## OSM/IN DECISION

<b>Standard:</b> EN 60670-1:2005	<b>Sub clause:</b> 7 - 15	<b>Sheet N°:</b> OSM/IN 254
<b>Subject:</b> Classification of flush-mounting boxes according to clause 7, Table 1, and consequent applicability of clause 15 “Mechanical tests”	<b>Key words:</b> <ul style="list-style-type: none"> <li>- flush-mounting boxes</li> <li>- mechanical tests</li> </ul>	<b>Meeting N°:</b> 20 (2010)  <b>Item:</b> 3.3.2 c)

A = Box (not accessible after the completion of the building process)  
 B = Cover-plate for accessories (accessible)

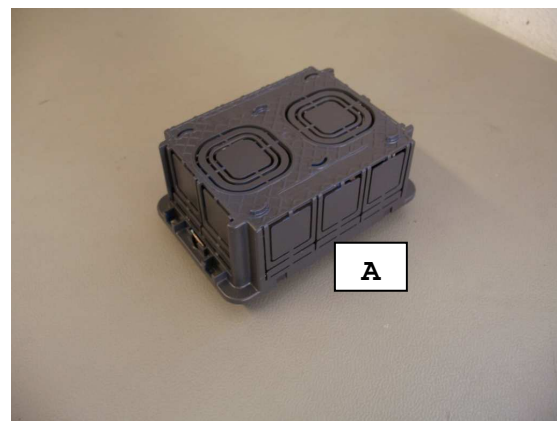
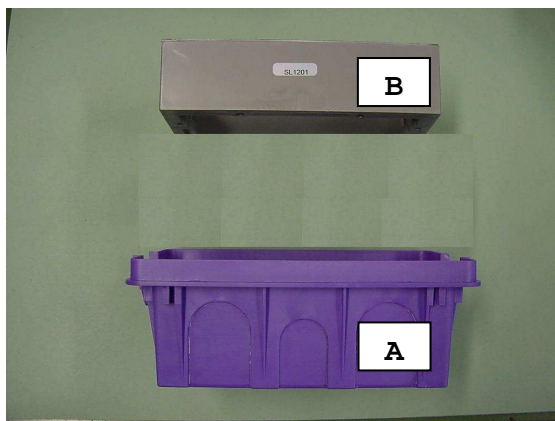
**Question:** In the pictures below, flush-mounting boxes designed for non-combustible walls and not suitable for installation into concrete during the casting process are given as example. No parts are intended to be accessible after the completion of the building process.

How the above mentioned flush-mounting boxes (parts A) can be classified?  
 Which requirements of clause 15 “Mechanical tests” shall consequently be applied?

**Decision:** In clause 7, Table 1, boxes and enclosures may be suitable for more than one method of installation (7.2, note a). Therefore only one method of installation is not precluded.

The above mentioned flush-mounting boxes may be classified by the manufacturer according to 7.2.1.1 only (7.2.3.2 is excluded).

- parts A and B **are not** subjected to sub-clauses 15.1 “Impact test at low temperature” and 15.2 “Compression test”;
- parts A classified according to 7.5.1 (-5 °C to +60 °C) **are not** subjected to sub-clause 15.3 “Impact test for boxes and enclosures”;
- parts A classified according to 7.5.2 (-15 °C to +60 °C) and 7.5.3 (-25 °C to +60 °C) **are** subjected to sub-clause 15.3 (but in the standard it is not specified the duration of conditioning at the minimum temperature during installation);

- parts B **are** subjected to sub-clause 15.3.
